ADDENDUM NO.06: SECTION 00 91 06

UNIVERSITY OF TORONTO
ROBARTS LIBRARY - 5TH FLOOR MAP & DATA LIBRARY
PROJECT NUMBER P006-22-176

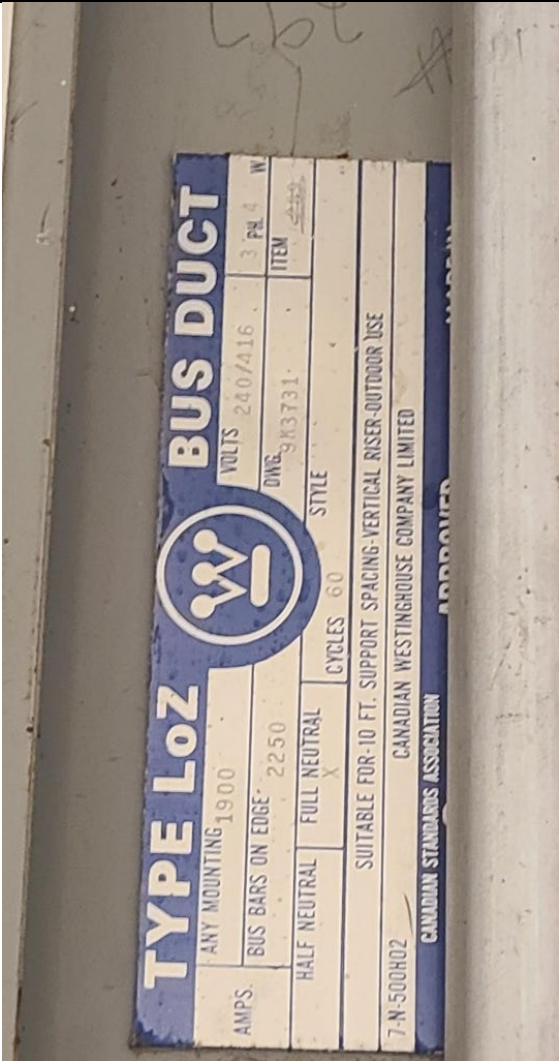
Q63. "Delivery Path

We have a length of HSS that is 22' long (6.6M). Do you know if there is a delivery path for getting this up to the 5th floor?

SEE ATTACHED FILE IN FOLDER."

A63. *If the 22' HSS does not fit into the service elevator, it can be split in two parts and welded together on site as long as stiffness of the section is maintained.*

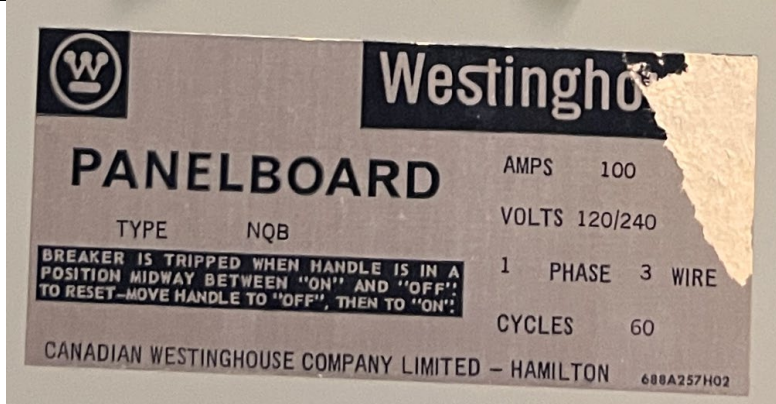
Q64. "Bus Duct (4 questions in total)

- 1) This project has 3 bus duct runs – riser A, B and C that each require a new 400A bus plug. Originally, we were provided with one picture from the initial site walk through that showed one of the bus duct runs which confirmed the manufacturer to be Westinghouse. The picture did not identify whether it was for riser A, B or C. Please provide pictures for ALL 3 bus duct runs that clearly identify the manufacturer as well as the name plate confirming system voltage, grounding, neutral size, etc.

- 1) *A The 3 bus ducts are identical in terms of sizing. Name plate snipped below.*

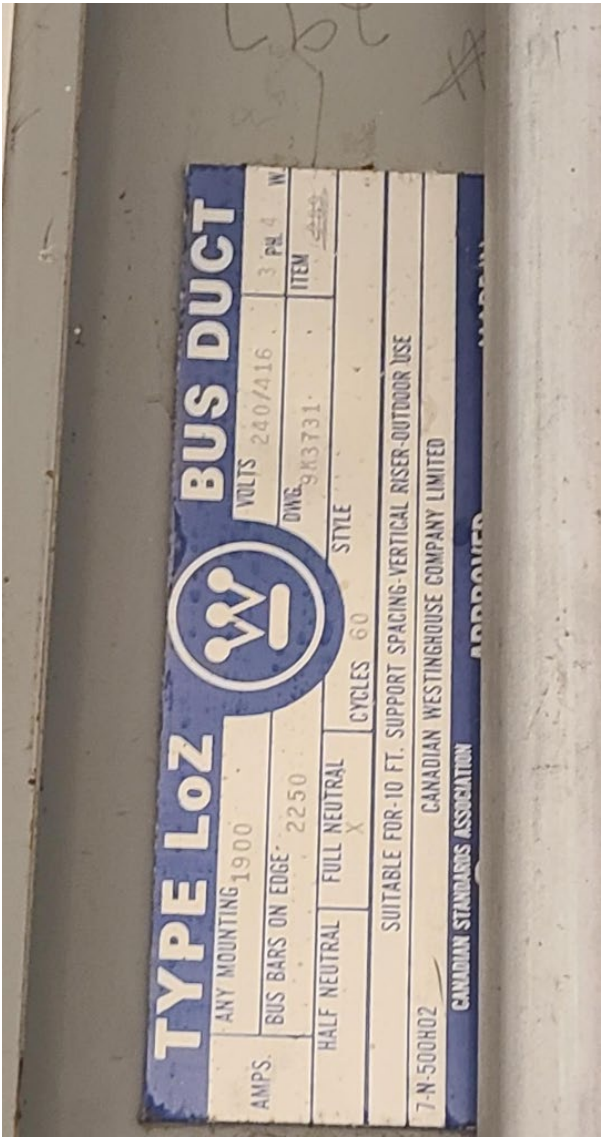
Q70. "Existing busduct

Please provide the information? make, model, and name plate photos, about the existing busduct, so that we can quote the following new bus plugs accordingly:
SEE ATTACHED FILES IN RFI FOLDER"

A70. *The 3 bus ducts are identical in terms of sizing. Name plate snipped below.*
